**DEVIATION REQUEST
 AND DECISION FORM**

Project Name : **Retreat at PrairieRidge Filings 1-3 Preliminary Plan**
 Schedule No.(s) : 52280-00-024 & 52280-00-025
 Legal Description : See attached

A deviation from the standards of the ECM in **Chapter 2.3.7.D.2, 2.3.7.D.3, 2.2.4.B.2, 2.2.5.B and Table 2-6** is requested.

RETREAT AT PRAIRIERIDGE FILINGS 1-3 PRELIMINARY PLAN FILING 1 & 2			
DESIGNED BY	MAW	SCALE	DATE 5/29/2024
DRAWN BY	MAW	(H) 1" = 60'	SHEET 7 OF 28
CHECKED BY	(V) 1" = N/A	JOB NO.	1305.10

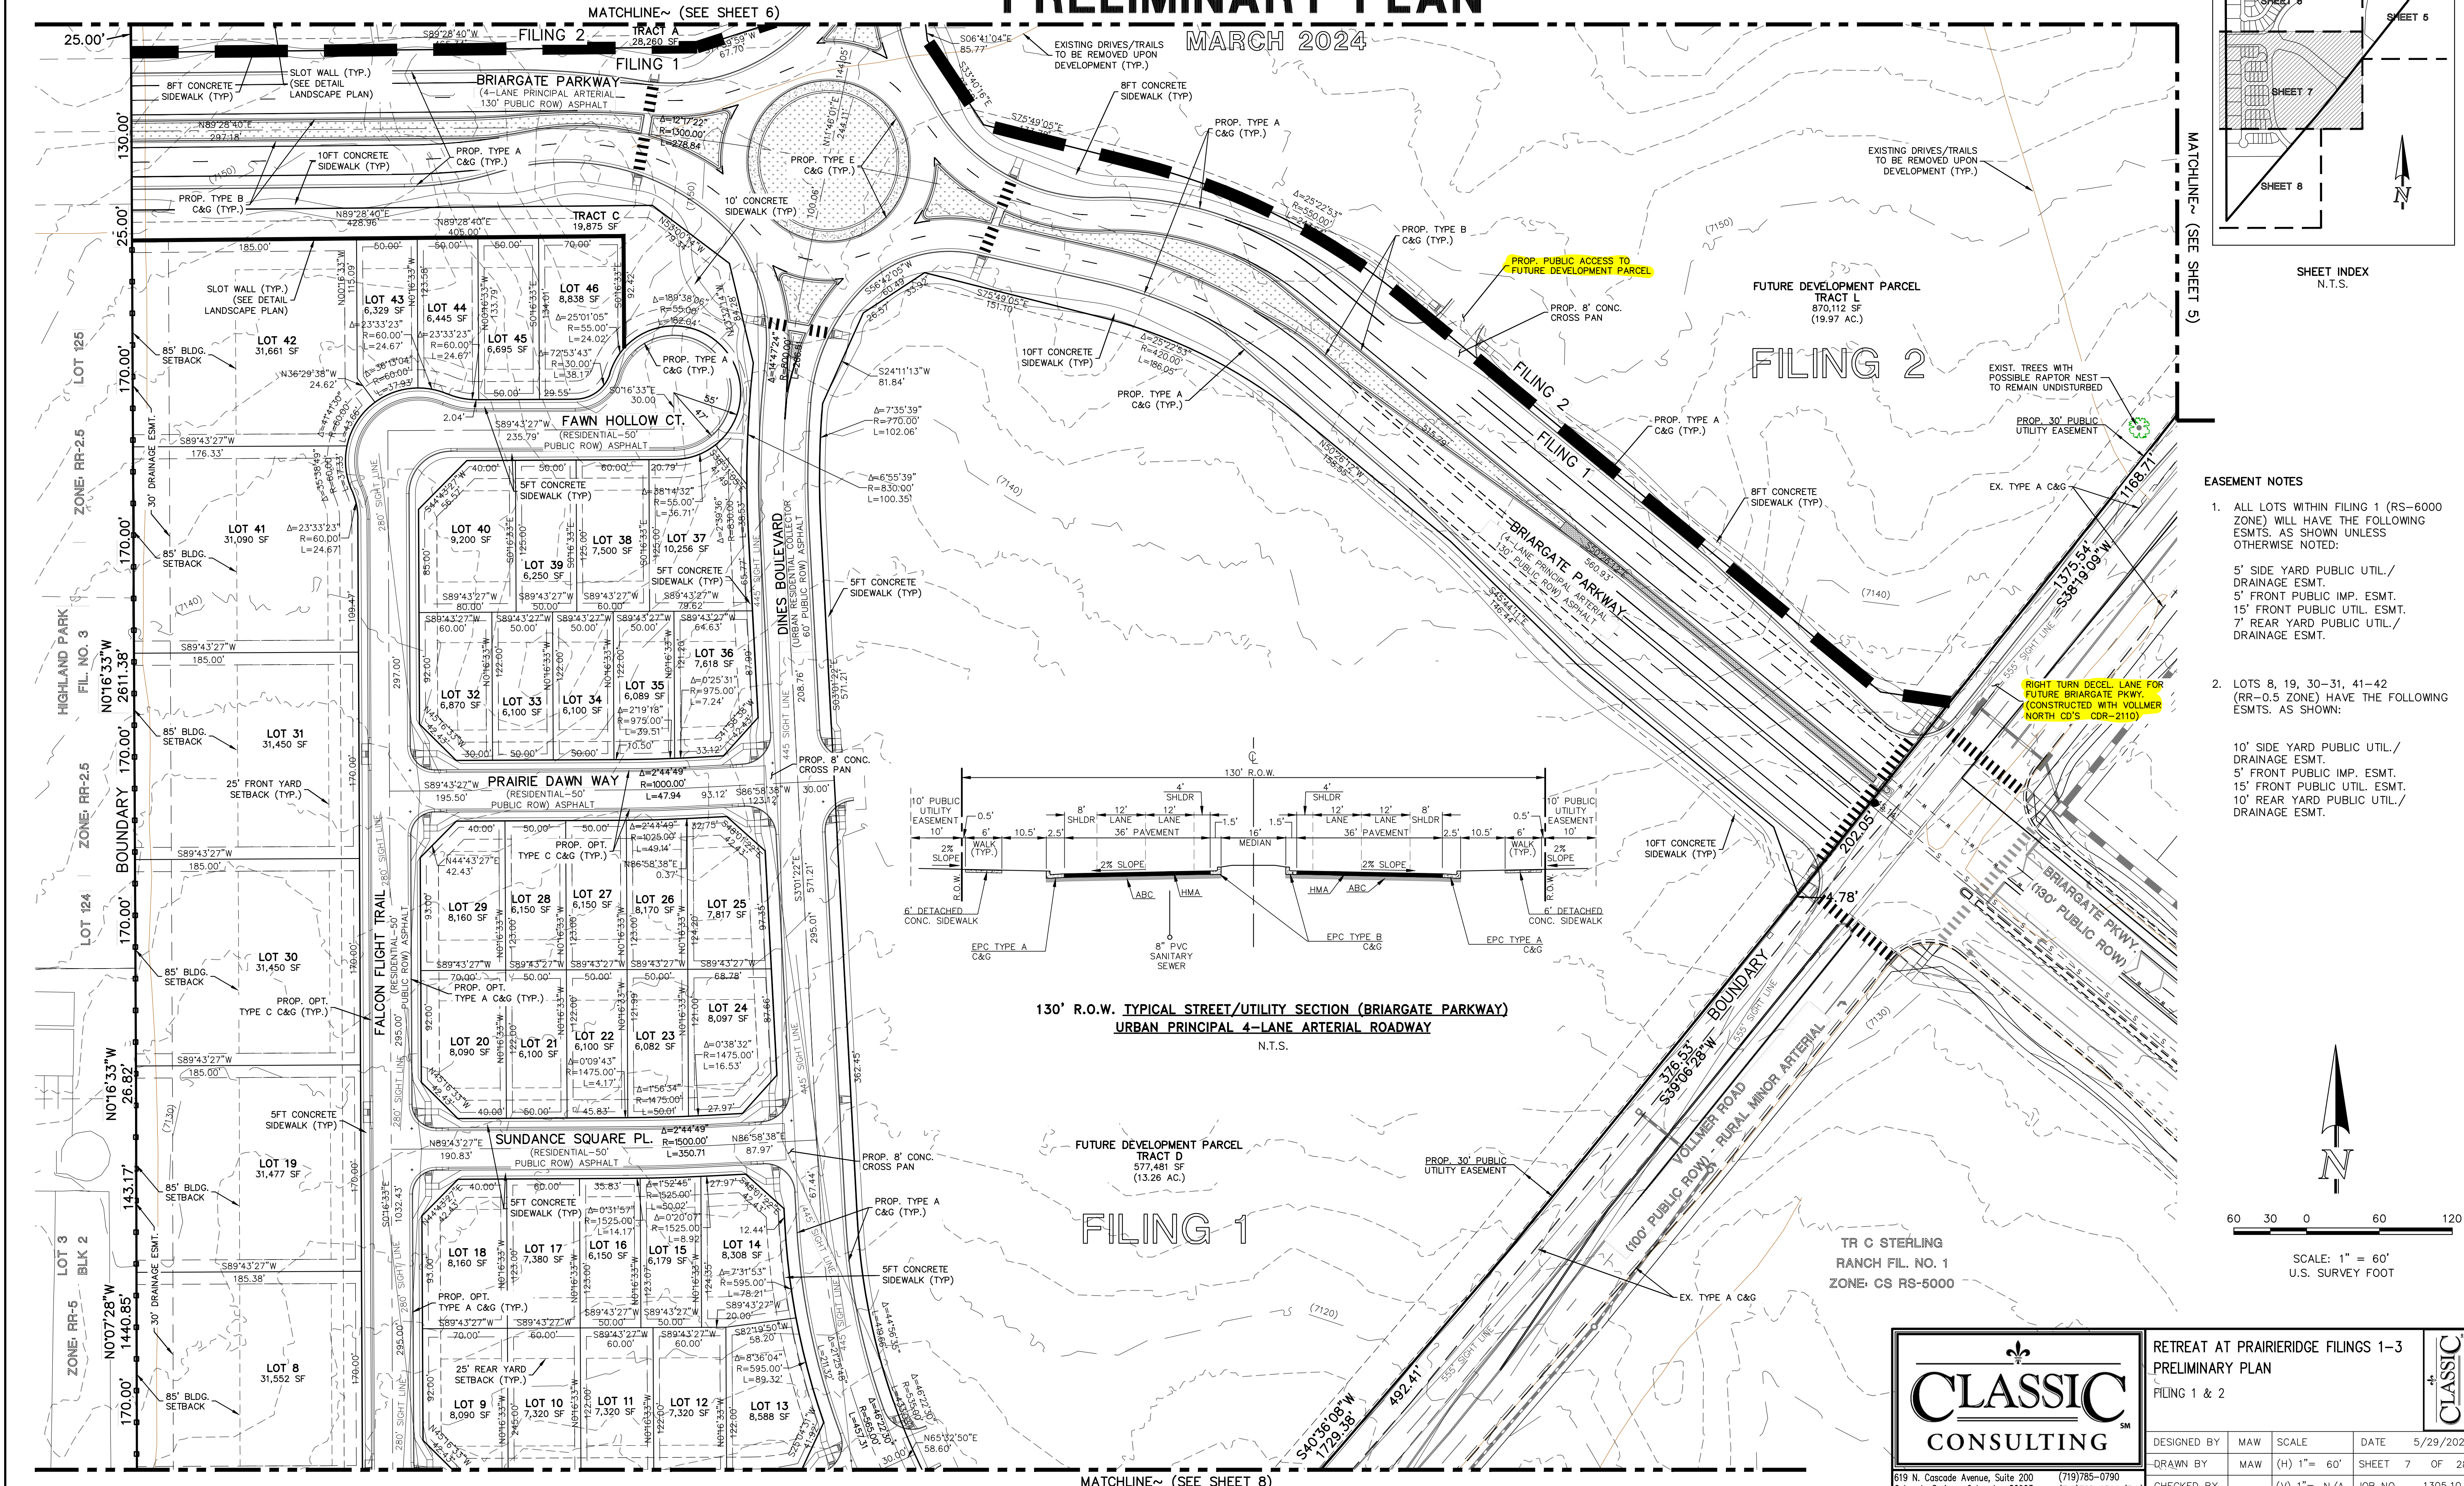
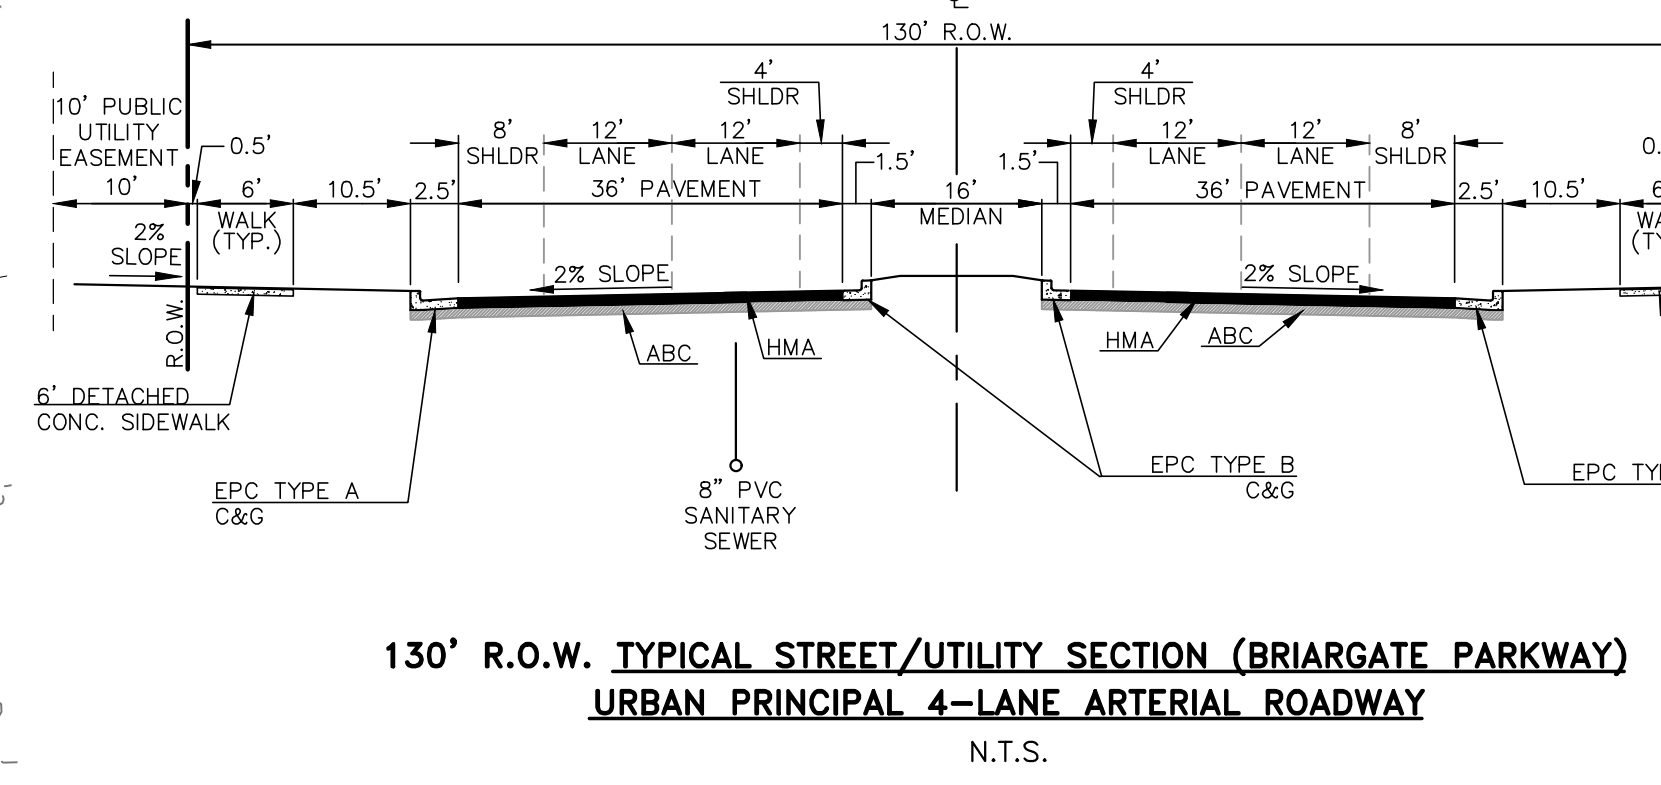
No acceleration lane proposed for west-bound Briargate Pkwy. at Vollmer Road
Intersection spacing less than ½ mile on Briargate Pkwy. between Vollmer Road and round-about
Proposed direct lot access (RI/RO) from Briargate Pkwy. and (RI only) from Vollmer Road into future Commercial site

Acceleration lane on west-bound Briargate Pkwy. in combination with the proposed right turn lane into the commercial site would likely cause some unwanted traffic weaving. The intersection of Briargate Pkwy. and Vollmer Road will eventually be signalized to allow for gaps in traffic. The posted speed limit on west-bound Briargate Pkwy. approaching the round-about will most likely be reduced to 40 mph or less.

The proposed alternative is to provide a right turn deceleration lane on west-bound Briargate Pkwy. into the commercial site and a two-lane urban round-about approximately 1000 LF west of the Vollmer intersection, both as presented on the approved Jaynes Property Sketch Plan. A Right-In only with required deceleration lane from Vollmer Road into the commercial site is also proposed, similar to the same access type directly across Vollmer into the Homestead North Filing No. 1 subdivision.

In this specific situation, a round-about is proposed on Briargate Pkwy. approximately 1000 LF west of Vollmer Road (per the approved Jaynes Property Sketch Plan – SKP225) which will provide for a reduction in speed below 40 mph that helps reduce the need for an acceleration lane.

Also, with the proposed right turn deceleration lane on Briargate into the commercial site and no acceleration lane, there will not be any unwanted weaving and conflicting traffic movements.

The Right-in only off of Vollmer Road into the commercial site provides the second point of access to this site that will be topographically constrained upon development.
